ENGINE - INCORPORATE DRY FILM LUBRICANT TO THE NO.2 AND NO.10 STRUTS THRUST MOUNT
BRACKETS - CATEGORY CODE 5 - MOD.ENG-72-0045

V2500-ENG-72-0045

**SERVICE BULLETIN**

Location of the No.2 and No.10 Struts Thrust Mount Brackets
Fig.1

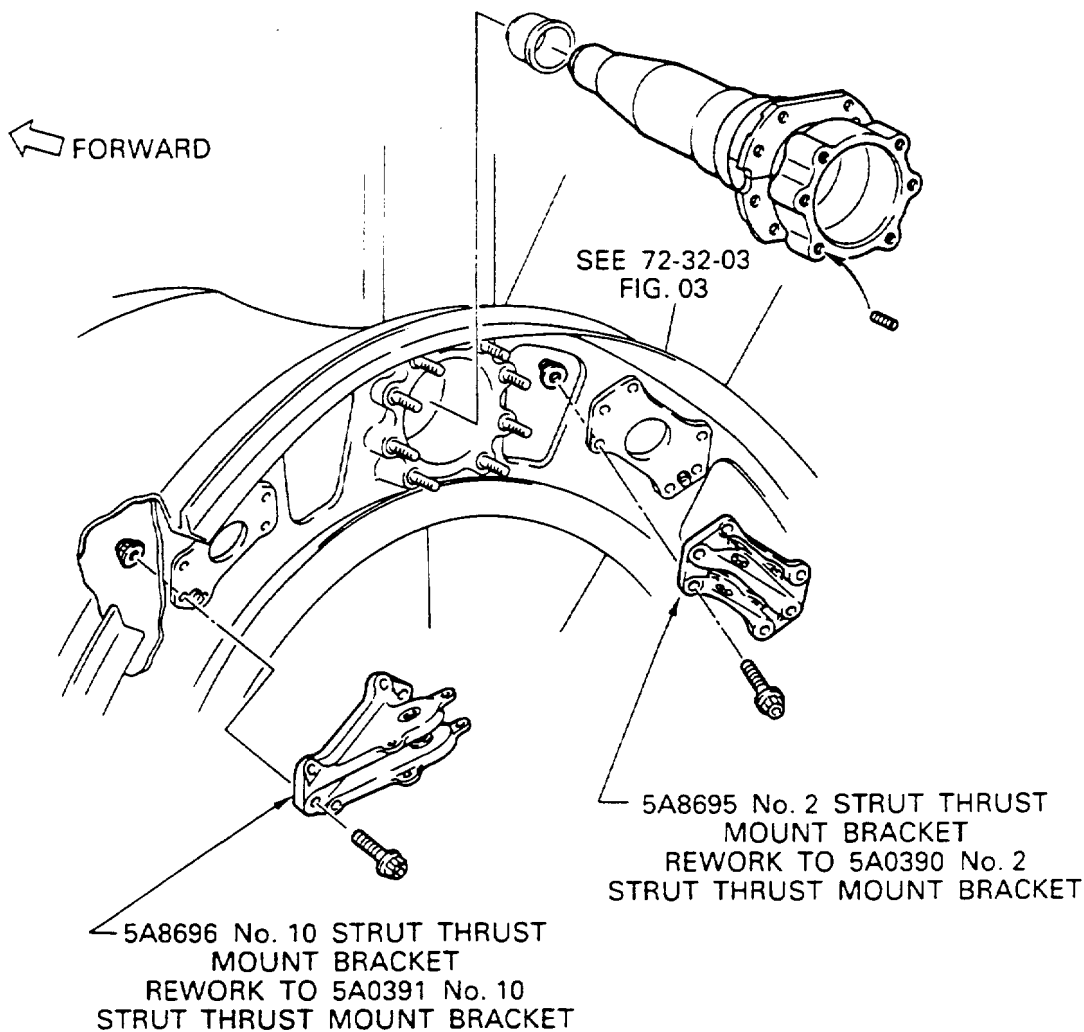
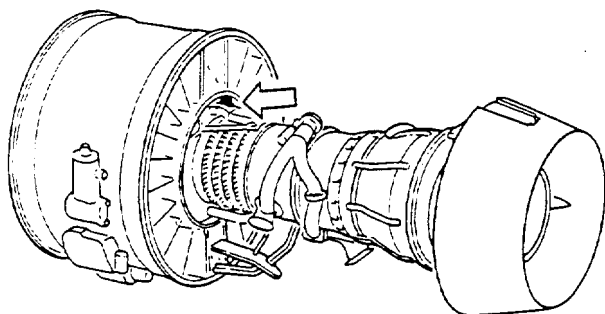
- (1) Remove 5A8695 and 5A8696, No.2 and No.10 Struts Thrust Mount Brackets by the approved procedures in the Engine Manual, 71-21-11, Removal. (Refer to Figure 1, and 1.K.(1)).
- (2) Examine the each spigot outside diameter on 5A8695 and 5A8696, No.2 and No.10 Struts Thrust Mount Brackets. (Refer to Figure 2).

- (1) Install new or reidentified 5A0390 and 5A0391, No.2 and No.10 Struts Thrust Mount Brackets by the approved procedures in the Engine Manual, 71-21-11, Installation. (Refer to Figure 1, and 1.K.(1)).

Rework of the No.2 and No.10 Struts Thrust Mount Brackets
Fig.2 Sheet 1 of 3

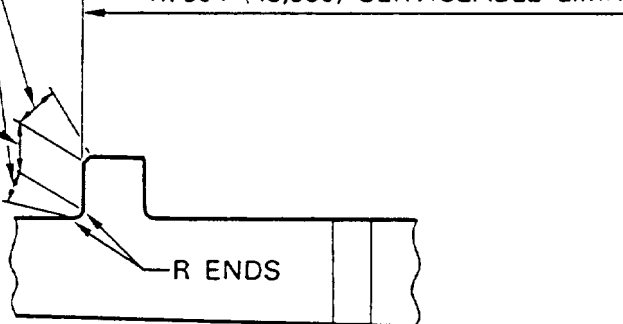
(a) A Dry Film Lubricant with the thickness between 0.0002 and 0.0005in. (0,003 and 0,015 mm.) is coated to the spigot outer surfaces of the No.2 and No.10 Struts Thrust Mount Brackets to prevent the wear during engine operation. (See Figures 1 and 2).

5A8695 No. 2 STRUT THRUST MOUNT BRACKET
APPLY THE DRY FILM LUBRICANT

OVERCOATING OF THE DRY
FILM LUBRICANT IS
PERMITTED ALL ROUNDS.

APPLY THE DRY FILM
LUBRICANT ALL ROUNDS
WITH 0.0002 - 0.0005
in. (0,003 - 0,015 mm)
OF THE COATING
THICKNESS.

1.7319 (43,991)
 \varnothing 1.7313 (43,975)
 \varnothing 1.7304 (43,950) SERVICEABLE LIMIT

NOTE: If the spigot outside diameter is between 1.7304 and 1.7313in. (43,950 and 43,975 mm.), send the Bracket(s) also for rework by this Service Bulletin.

If the spigot outside diameter is less than 1.7304in. (43,950 mm.), the Bracket(s) must be rejected.

NOTE: The coating thickness must be between 0.0002 and 0.0005in. (0,003 and 0,015 mm.) all rounds.

Rework of the No.2 and No.10 Struts Thrust Mount Brackets
Fig.2 Sheet 2 of 3

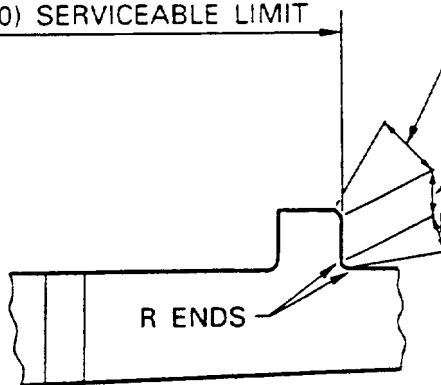
5A8696 No. 10 STRUT THRUST MOUNT BRACKET
APPLY THE DRY FILM LUBRICANT

DIAMETER BEFORE COATING

1.7319 (43,991)

Ø1.7313 (43,975)

Ø1.7304 (43,950) SERVICEABLE LIMIT

Rework of the No.2 and No.10 Struts Thrust Mount Brackets
Fig.2 Sheet 3 of 3

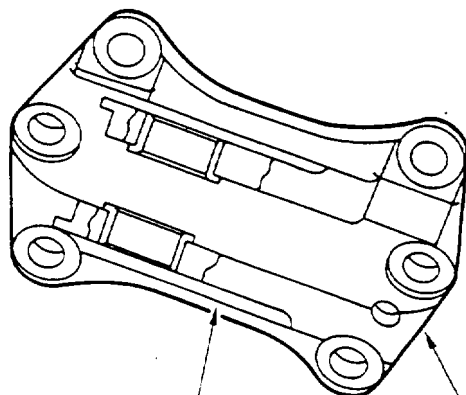
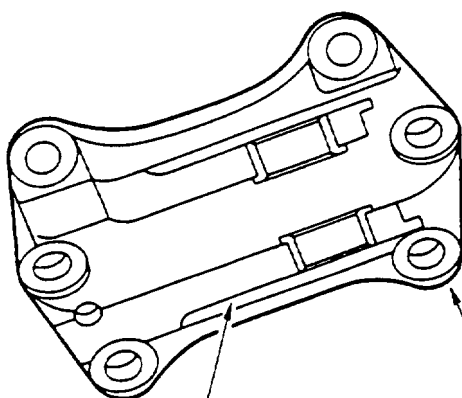
MARK NEW PN 5A0390 BY ELECTROLYTIC
ETCH ADJACENT TO OLD PN 5A8695
IDENTIFIED HERE.
MARK TWO LINES (==) ON THE OLD PN
WITH ELECTROLYTIC ETCH TO ERASE IT.

MARK NEW PN 5A0391 BY ELECTROLYTIC
ETCH ADJACENT TO OLD PN 5A8696
IDENTIFIED HERE.
MARK TWO LINES (==) ON THE OLD PN
WITH ELECTROLYTIC ETCH TO ERASE IT.

- (3) Renumber by the Electrolytic etch adjacent to the existing Part Numbers on each of No.2 and No.10 Struts Thrust Mount Brackets
- Refer to Figure 2, Sheet ? and 1.K.(2), 70-09-00, Marking of Parts
